ITEM E5 - Katamar Subdivision 2022

KPB File # 2022-020

KATAMAR SUBDIVISION 2022

STAFF REPORT

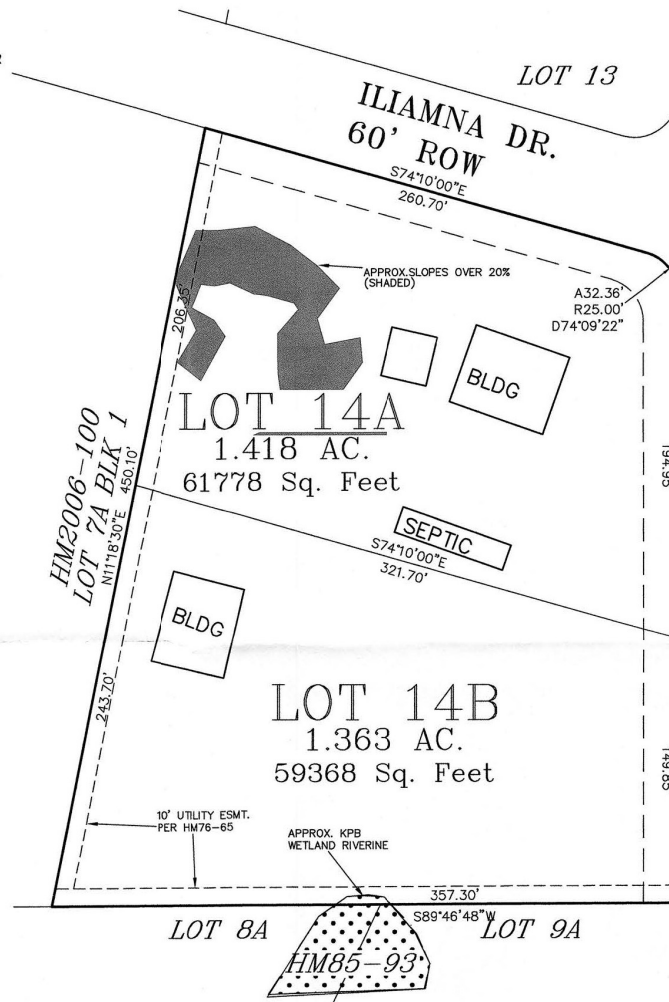
A current drive is present off Iliamna Drive. Lot 14A will continue to have access off Iliamna Drive and Brown Drive. Lot 14B will have access from Brown Drive. There is currently a structure on Lot 14B that appears to be accessed from the shared drive off Iliamna Drive. **Staff recommends** if the ownership changes for Lot 14B and the drive is intended to be shared, a shared driveway easement document should be created and recorded.

Site Investigation: The property does have slopes present. The areas with slopes greater than 20 percent are shaded on the plat. A small area within the southern portion of the subdivision contains wetlands. **Staff recommends** the shading for the slopes be removed from the final and the wetlands remain in place and place a note that a wetlands determination may be required.

Several structures are present and are depicted on the plat. The depiction of the structures is not required on the final plat but if they remain **staff recommends** a label be added to the other structure on Lot 14A.

Utility Easements The parent plat granted utility easements along the western and southern boundary of the parent lot. Those easements are depicted and the parent plat is noted. The parent subdivision did not grant any utility easements along the right of ways. **Staff recommends** a plat note be added to grant the code required utility easements along right of ways and depict the utility easements on the plat.

Provide a label for the 20 foot building setback that is depicted.

- D. A vicinity map, drawn to scale showing location of proposed subdivision, north arrow if different from plat orientation, township and range, section lines, roads, political boundaries, and prominent natural and manmade features, such as shorelines or streams;
Staff recommendation: *The township and ranges within the vicinity map boundary should be labeled.*

- *Provide a block label for Lot 13 located north of Iliamna Drive.*
 - *Provide a block label for Lots 4 and 6 located east of Brown Drive.*
 - *Update the label for the lot north of Iliamna Court to "Lot 1A Block 2".*

- J. Block and lot numbering per KPB 20.60.140, approximate dimensions and total numbers of proposed lots;
Staff recommendation: Provide a "Block 1" label for the new lots.

- The front 10 feet adjacent to right of ways is granted as a utility easement by this plat.
- Any person developing the property is responsible for obtaining all required local, state, and federal permits, including a U.S. Army Corps of Engineers wetland determination if applicable.
- Any items present on the Certificate to Plat that require notation on the plat.
- The correct wastewater disposal note as determined by the engineers report.
